# Access Compliance Report

## Public Rights-of-Way

### (Curb Ramps)

Intersection ID: 8871	Main Street: NORRIS_AV	Cross Street: ISENHOUR_ST	Location: NW
ADA ID: CB17EB72364F	Ramp Type: Perp	Initial Pass/Fail: Fail	Overall Compliance: No
Codes/Mitigation Info/Possible Solution		Field Measurements/Component Compliance	
Severity Score: 33.75

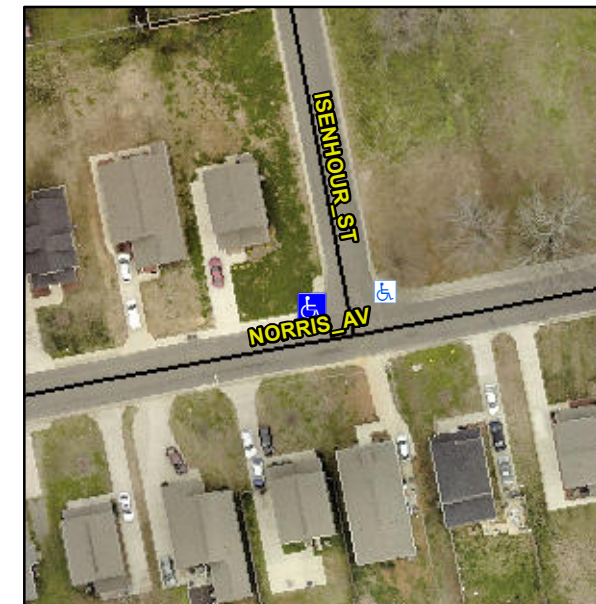
**Not Found, R304.5.1, R304.2.2**

Compliance	Description	Data	Compliance	Description	Data
N/A	Ramp Length (in)	25.5	No	Ramp Slope (%)	12.5
No	Ramp Width (in)	46.5	Yes	Ramp XSlope (%)	0.3
N/A	Flare Type LT	N/A	N/A	Flare Type RT	N/A
N/A	Flare Slope LT (%)	N/A	N/A	Flare Slope RT (%)	N/A
N/A	Flare Traversable LT?	N/A	N/A	Flare Traversable RT?	N/A
N/A	Landing Length (in)	N/A	N/A	DWS Provided?	N/A
N/A	Landing Width (in)	N/A	N/A	DWS Contrast?	N/A
N/A	Landing Slope (%)	N/A	N/A	DWS Length (in)	N/A
N/A	Landing X Slope (%)	N/A	N/A	DWS Full Width?	N/A
N/A	Landing Curb? (Y/N)	N/A	N/A	DWS Offset (in)	N/A
N/A	Shared Landing?	N/A			
N/A	Gutter Ponding?	N/A	N/A	Gutter Slope (%)	N/A
N/A	Gutter Lip Ht (in)	N/A	N/A	Gutter X Slope (%)	N/A
N/A	Painted X Walk1?	No	N/A	Painted X Walk2?	N/A
	X Walk 1 Direction	To E		X Walk 2 Direction	N/A
N/A	X Walk 1 Width (in)	N/A	N/A	X Walk 2 Width (in)	N/A
	X Walk 1 Slope (%)	1.2		X Walk 2 Slope (%)	N/A
	X Walk 1 X Slope (%)	1.4		X Walk 2 X Slope (%)	N/A

**Remove & Replace Entire Ramp.**
